February 29, 2000

LaSalle County Station, Units 1 and 2  
Facility Operating License Nos. NPF-11 and NPF-18  
NRC Docket Nos. 50-373 and 50-374

Subject: Application for Amendment to Appendix A, Technical Specifications, Section 3/4.4.6, "Pressure/Temperature Limits, Reactor Coolant System," and Request for Exemption from 10 CFR 50.60, "Acceptance Criteria for Fracture Prevention Measures for Lightwater Nuclear Power Reactors for Normal Operation"

Figure 3.4.6.1-1

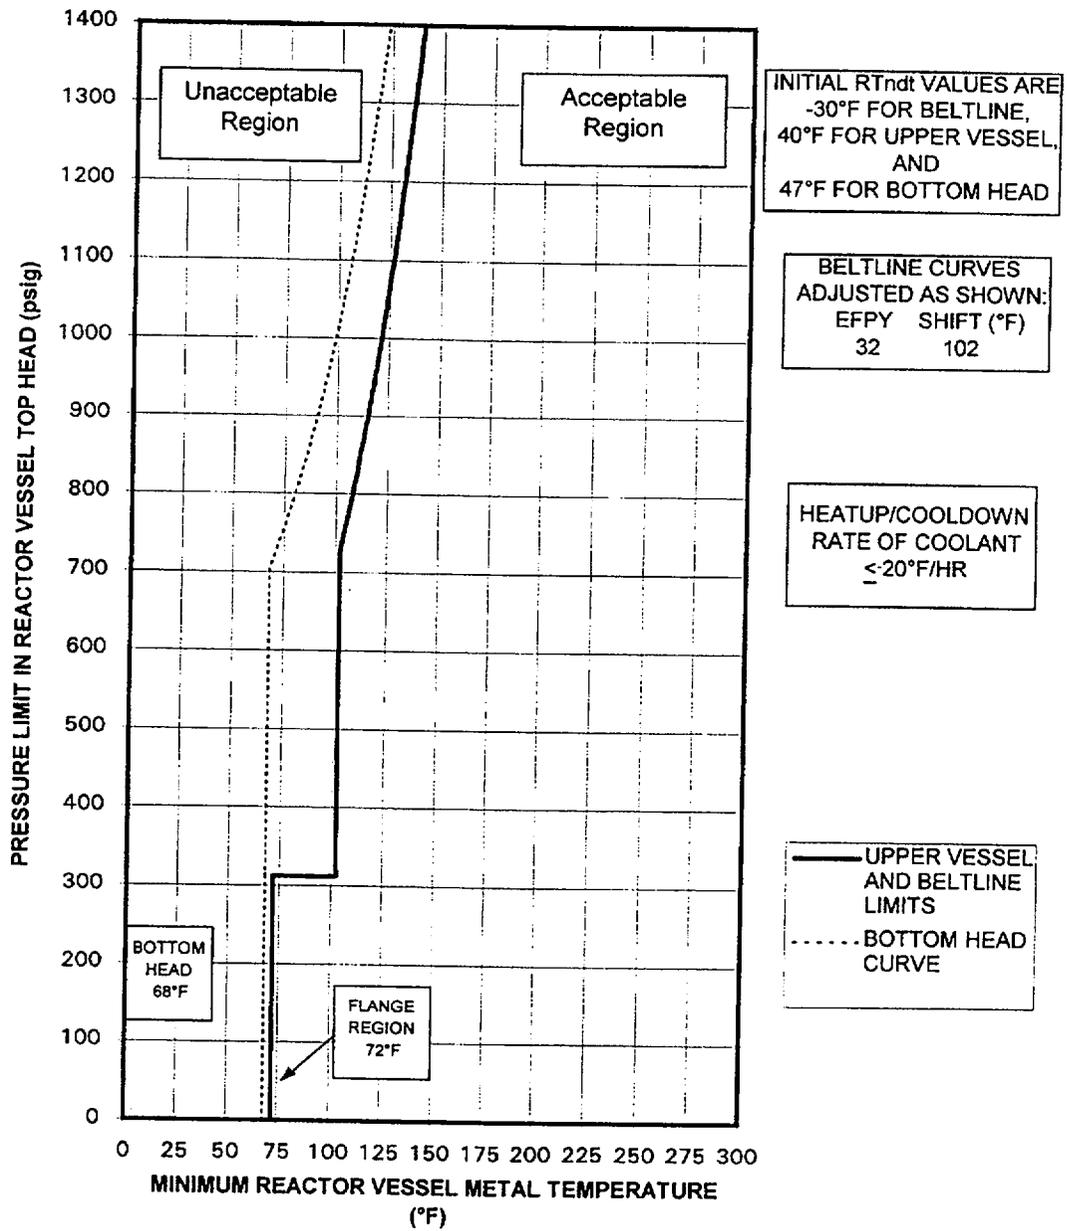
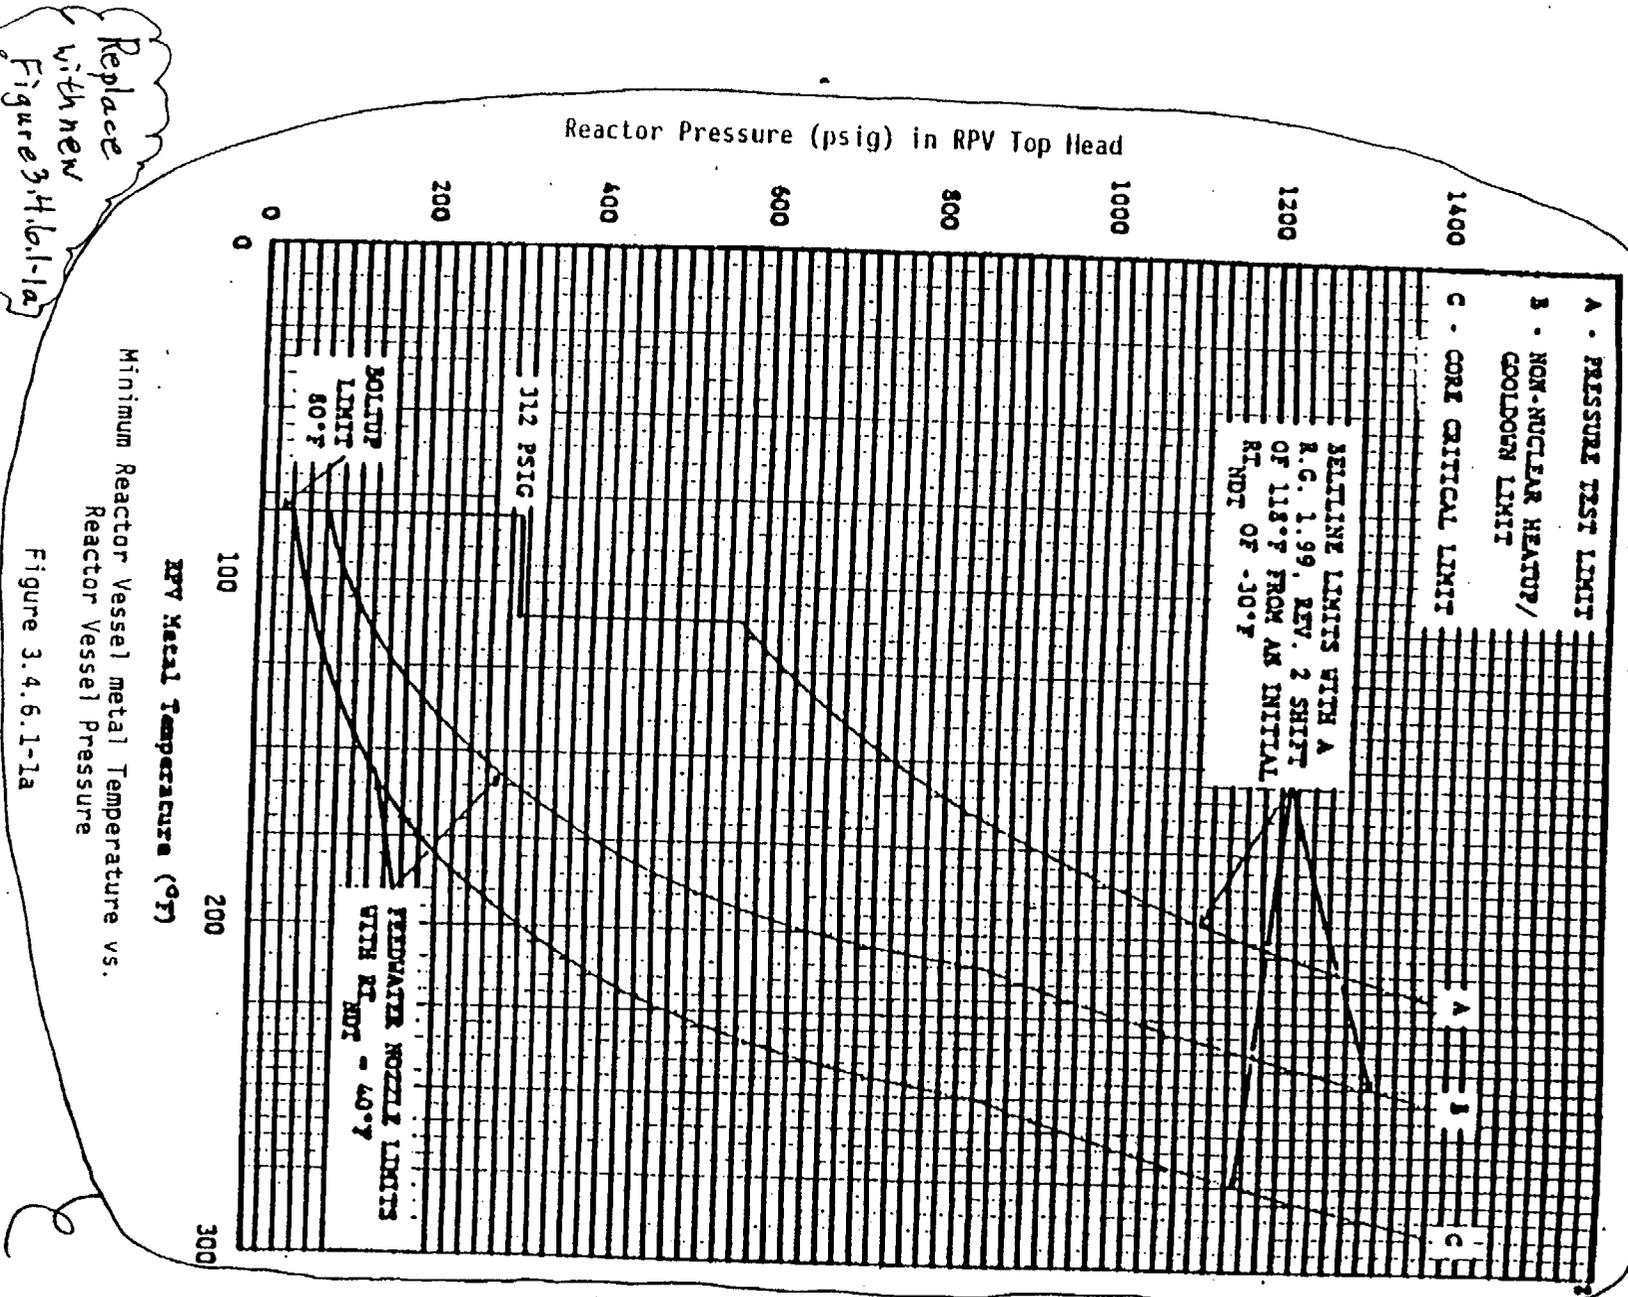
The proposed changes to TS Figures 3.4.6.1-1 and 3.4.6.1-1a are to replace the current 16 and 32 EFPY curves with three recalculated 32 EFPY curves and to change the associated descriptions contained on each page.

Replace with new Figure 3.4.6.1-1

Figure 3.4.6.1-1b

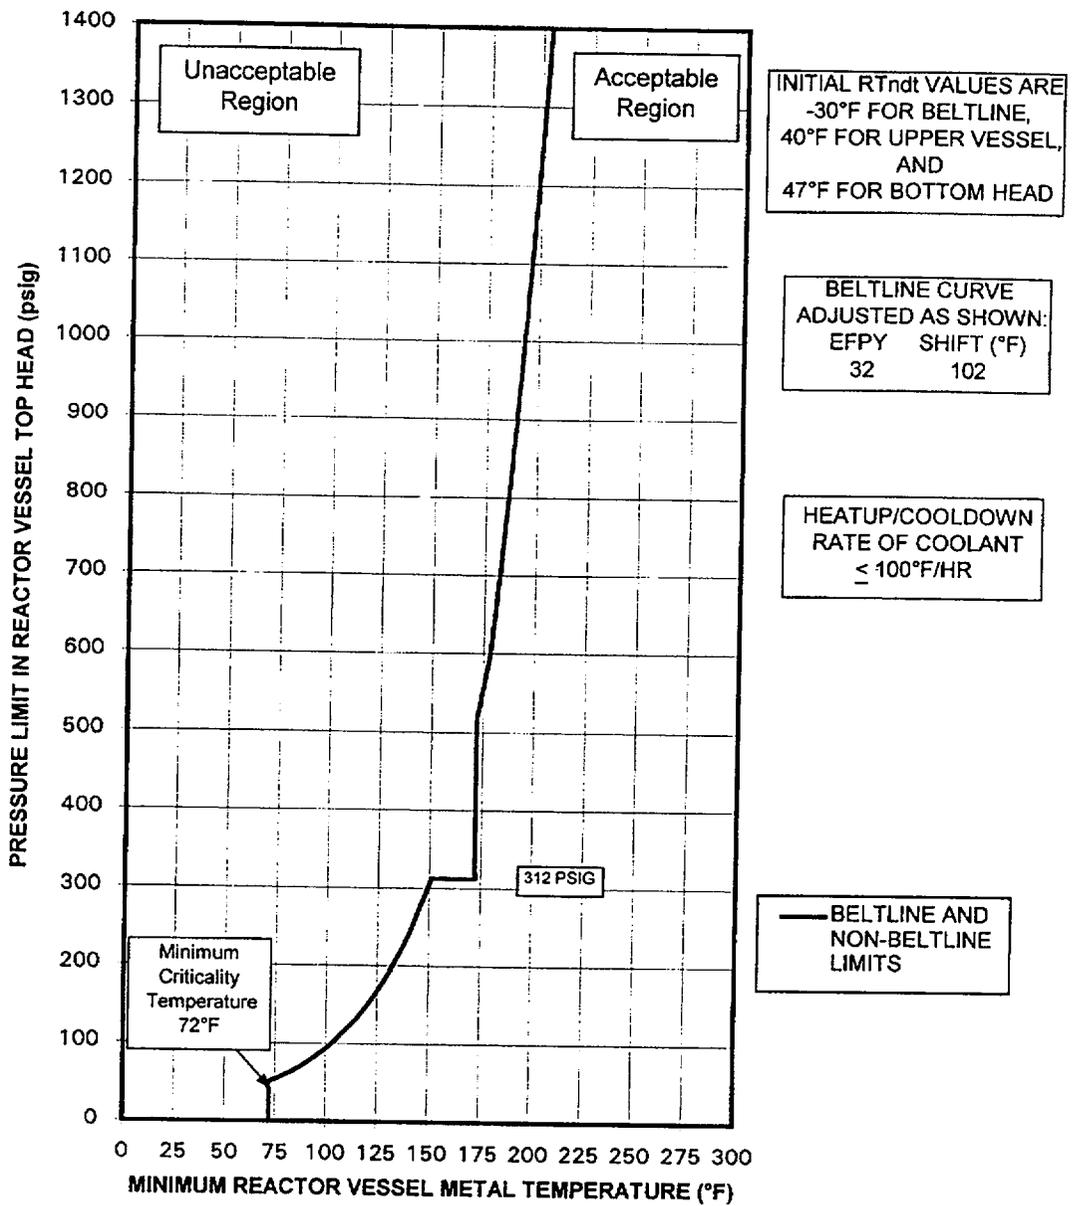
The proposed change to TS Surveillance 4.4.6.1.1 is to remove the reference to Curves A and B, and to include the reference to TS Figure 3.4.6.1-1b.

Replace with  
new Figure 3.4.6.1-1b

Figure 3.4.6.1-1a

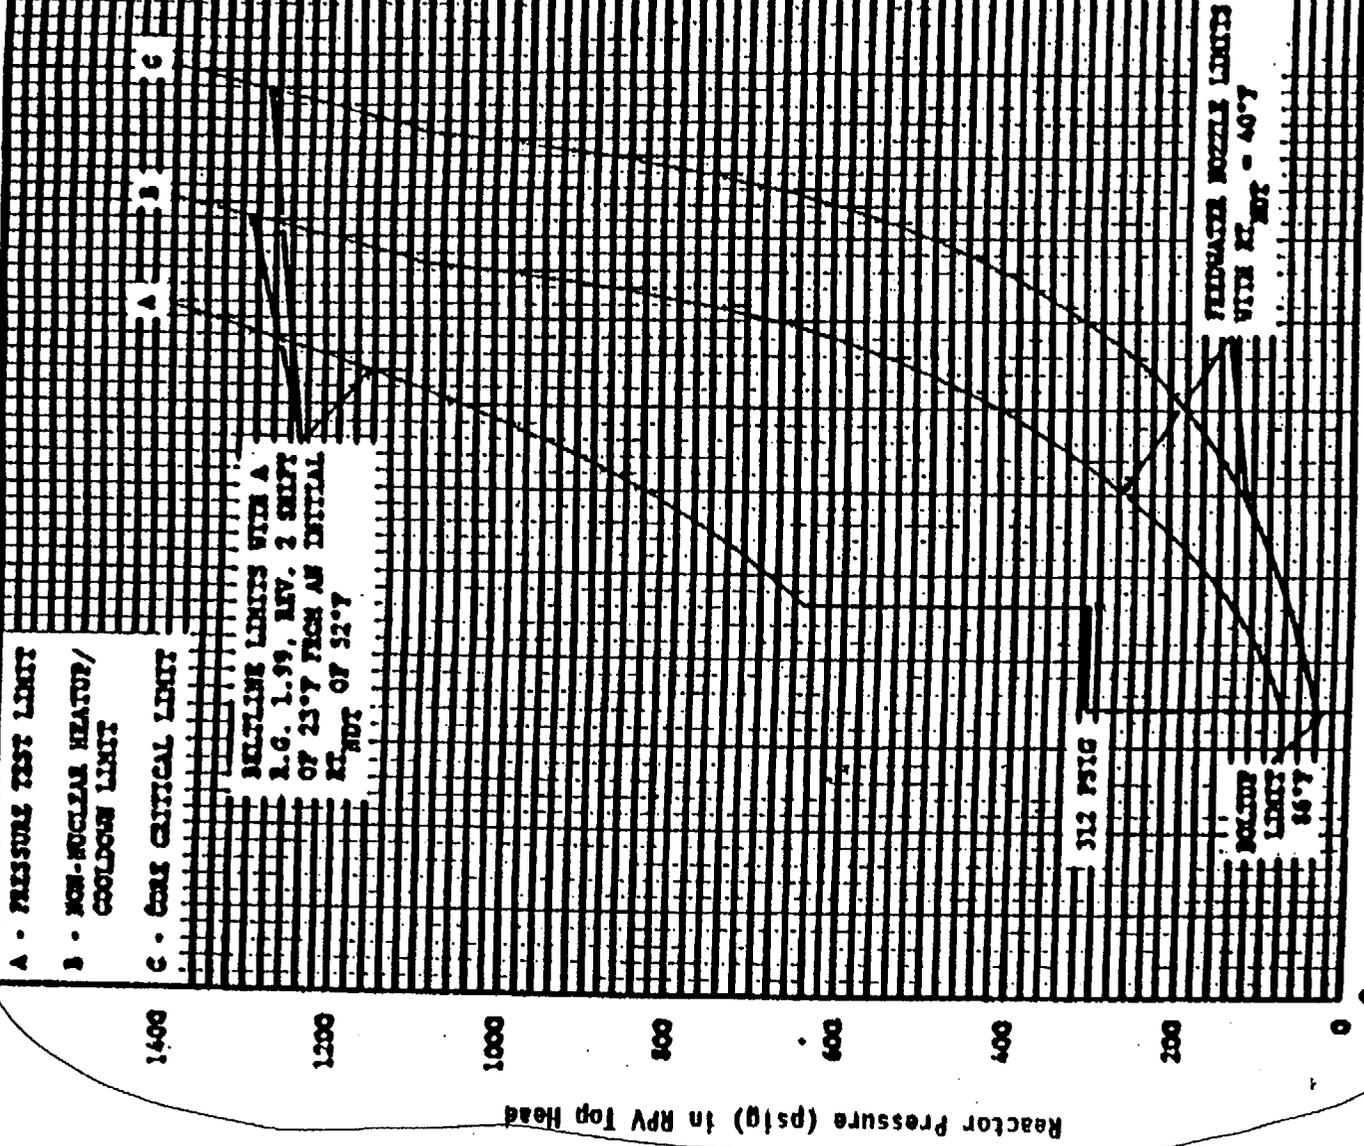
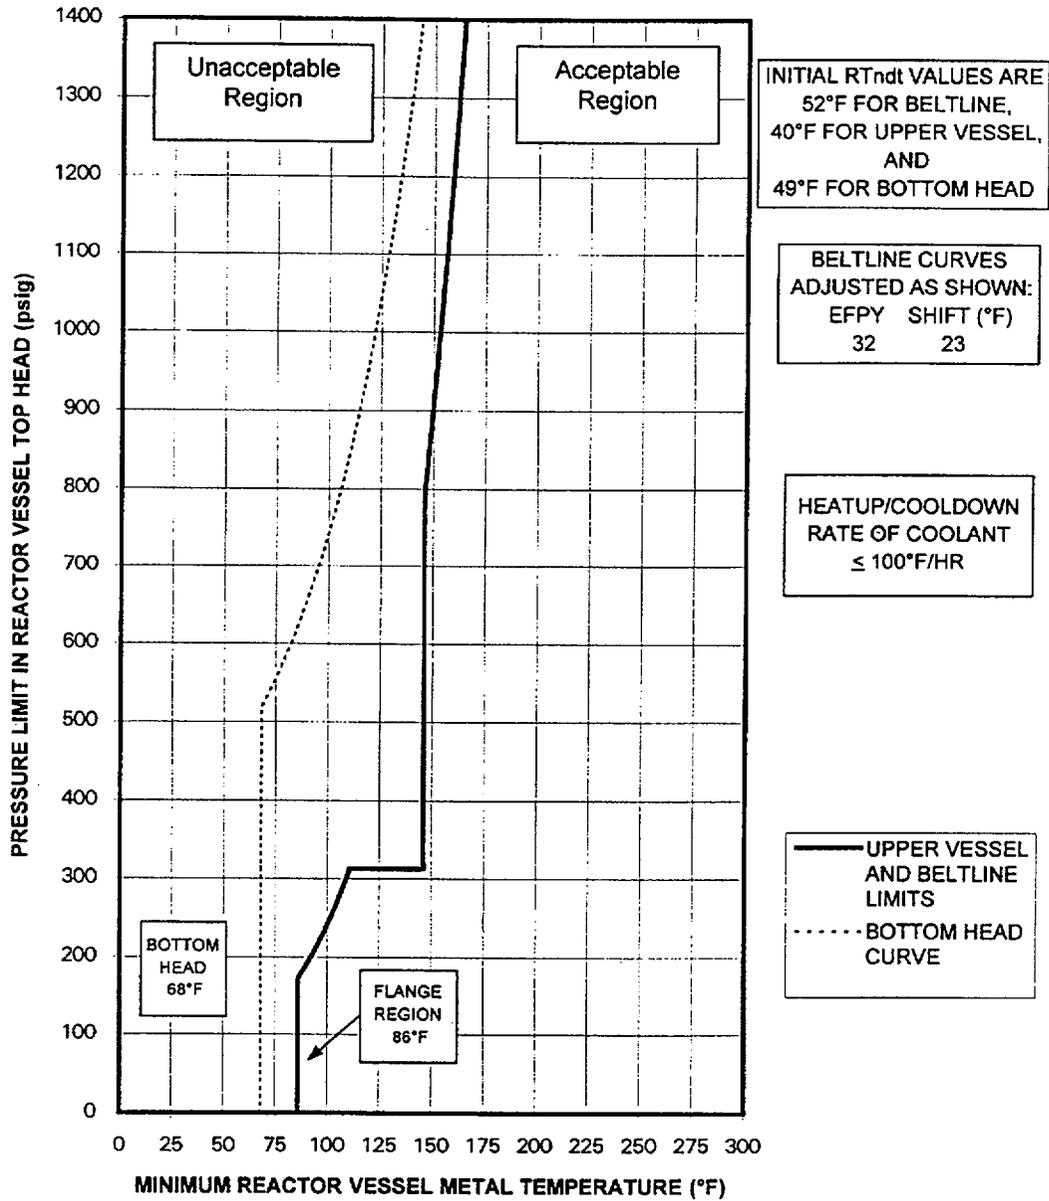
The proposed changes to TS Figures 3.4.6.1-1 and 3.4.6.1-1a are to replace the current 16 and 32 EFPY curves with three recalculated 32 EFPY curves and to change the associated descriptions contained on each page.

Replace with new Figure 3.4.6.1-1a

Figure 3.4.6.1-1b

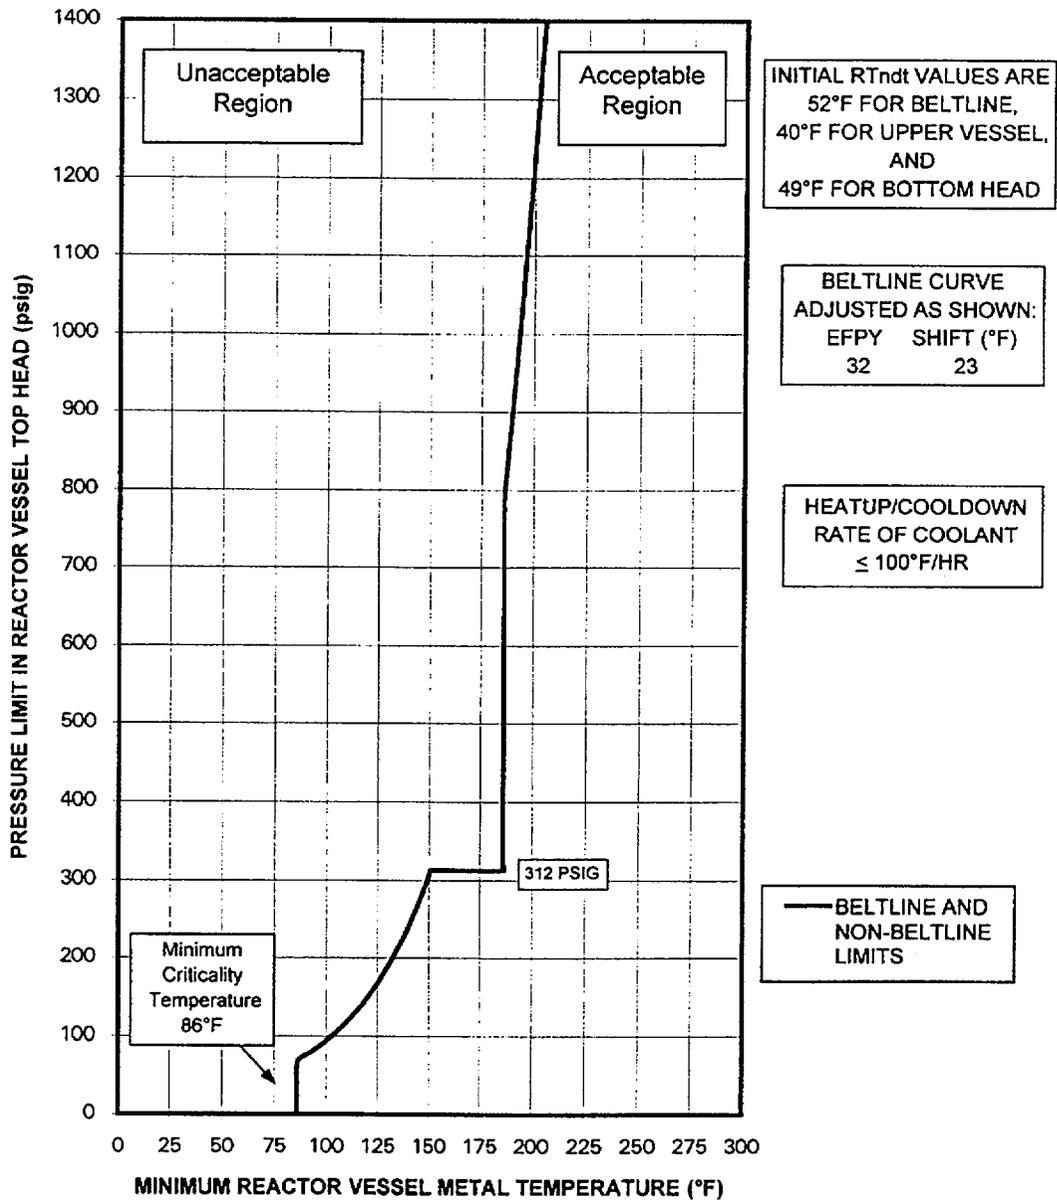
The proposed change to TS Surveillance 4.4.6.1.1 is to remove the reference to Curves A and B, and to include the reference to TS Figure 3.4.6.1-1b.

Replace with  
new Figure 3.4.6.1-1b
